# Appendix A - Additional assessment

# A.1. Housing Investigation Areas (HIAs)

- The Department's Urban Design Unit has undertaken an urban design peer review of Council's urban design reports and proposed controls.
- There is generally no objection to the proposed zones, heights and floor space ratios (FSRs), as stated in the Gateway report, subject to further investigations. Further detailed assessment in terms of urban design is in the five tables below.

Figure 3. Proposed zoning and height (in storeys) and landowner rezoning request. Department comment

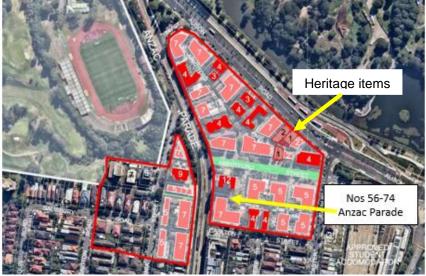
• The proposed heights and FSRs offer a transition from the Kensington centre (Figure 4 below) to surrounding low-medium density residential areas, and respond to the steep topography in the west of the HIAs by leaving these areas as 'no change'.

- The HIA contains 4 heritage items and there are heritage items adjacent to the HIA. The apparent bulk of 7 storeys adjacent to four 1-2 storey local heritage items will be mitigated by a stepped 2 and 7-storey form and laneway separation (Figure 3 & 4).
- The Department's urban design peer review concludes that there are opportunities:
   to improve solar access to:
  - properties between Boronia Street and Anzac Parade, and
  - existing strata-titled buildings; and
  - for Council to further test the proposed FSRs can be accommodated in and/or optimised by the proposed height controls while achieving solar access outcomes.

• A landowner request was submitted for 56-74 Anzac Parade, Kensington (a 12-storey building). The Department concurs with Council's justification to retain the R3 zone and apply no change to this property.

Figure 12. Existing (left) and proposed (right) alternative building heights. Source: planning proposal.

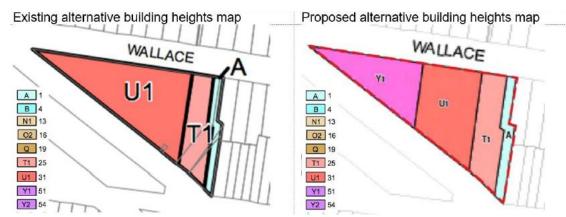
The Department notes that Council supports the proponent's request. The Department concurs with the justification from Council and the proponent because:

- The amendment would facilitate the realisation of the alternative FSR of 4:1 in the LEP, and allow more flexibility in the building design with good amenity, architectural and urban design outcomes.

- The proposed controls and concept scheme prepared by AJ+C demonstrates:
  - consistency with the K2K Planning Strategy design principles for tall landmark buildings in prominent, highly accessible locations in conjunction with the delivery of substantial public benefit. The proposed built form is in keeping with the character of other 'urban node' sites around the Five Ways intersection in Kingsford, which are characterised by towers emerging from the surrounding 9-storey form.

Figure 18. Existing Alternative building height map. Source: planning proposal, Randwick Council

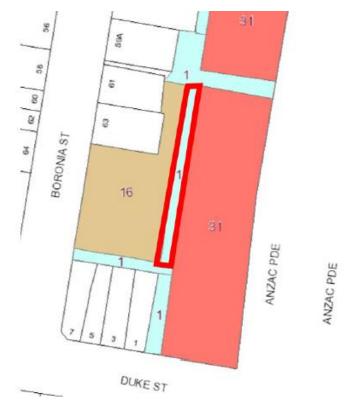
Council considered a previous land-owner request to amend the zoning, FSR and height controls as part of the K2K Planning Proposal which was not supported at that time. Council has considered a new request for these properties and has recommended that only the FSR and 1m height control to the rear of Anzac Parade properties be removed because:

- retaining the R3 zone for properties along Boronia Street is appropriate as they only have a frontage to Boronia Street, not Anzac Parade, and therefore is not consistent with the Kensington Town Centre. As such, extension of this town centre to the Boronia Street properties is not supported.

- the removal of the 1m height control from the lane is justified on the basis that:
  - the height control was originally intended for a rear lane however the fine grain narrow lots complicate the provision of a continuous rear laneway without site amalgamation; and

- if site amalgamation were to occur for redevelopment then servicing arrangements can be made from Boronia Street.
- any other height increases on the Boronia Street and Anzac Parade sites would disrupt the transition to surrounding development and be a departure from the K2K urban design strategy.

- the removal of the FSR control for the Boronia Street properties is consistent with those sites fronting Boronia Street to the south. Council states that the K2K DCP will be amended to encompass these three properties and to address design implications.
